**APPLICATION FOR FINAL RESUBDIVISION APPROVAL
43 GATES FARM ROAD-2 LOT RESUBDIVISION
MEETING DATE : DECEMBER 12, 2023**

**PUBLIC HEARING # 3
12/12/23 AGENDA**

Re: 43 Gates Farm Road Re-subdivision

The Engineering Division has reviewed plans for the proposed re-subdivision of land at 43 Gates Farm Road prepared by Megson, Heagle, and Friend Civil Engineers and Land Surveyors, LLC including plans revised November 15, 2023 and offers the following comments:

GENERAL NOTES & DETAILS
#43 GATES FARM ROAD RESUBDIVISION
PREPARED FOR
BRYAN FEERY
GLASTONBURY, CONN.

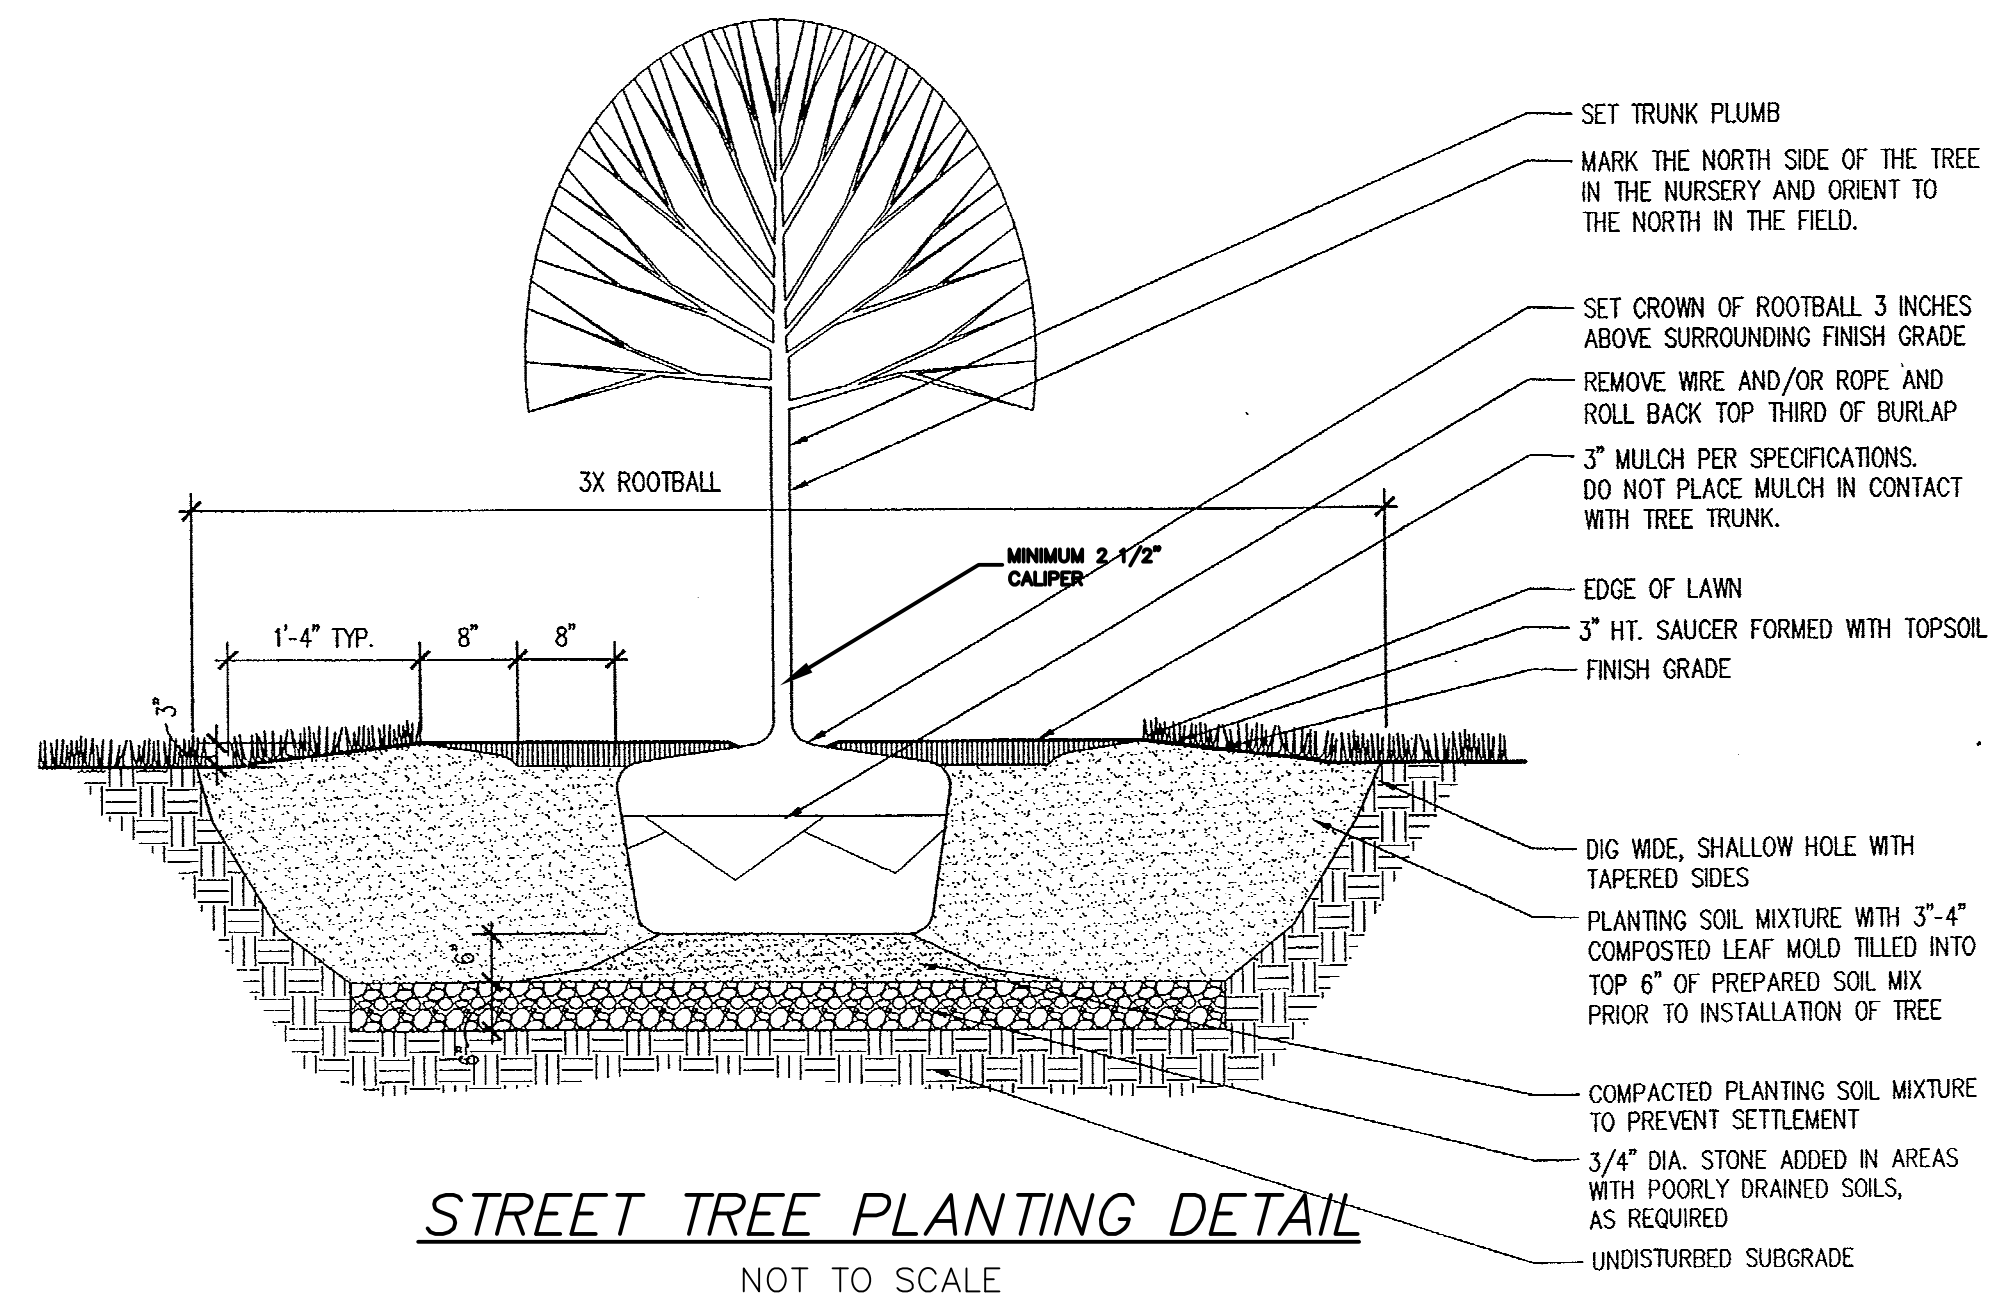
3. The stormwater system maintenance schedules on Sheets 6 and 7 need to state that such maintenance is the responsibility of the property owner. These maintenance narratives should be moved to the site plan to ensure that they are recorded on the land records.

4. Stormwater galleys should include an inspection manhole cover for ease of future access and maintenance.
5. Existing concrete sidewalks shall be removed across the driveway entrance as required to accommodate the proposed construction entrance. Concrete sidewalks shall be replaced across the driveway entrance in accordance with current Town standards. The Town standard sidewalk detail should be added to the plan set.
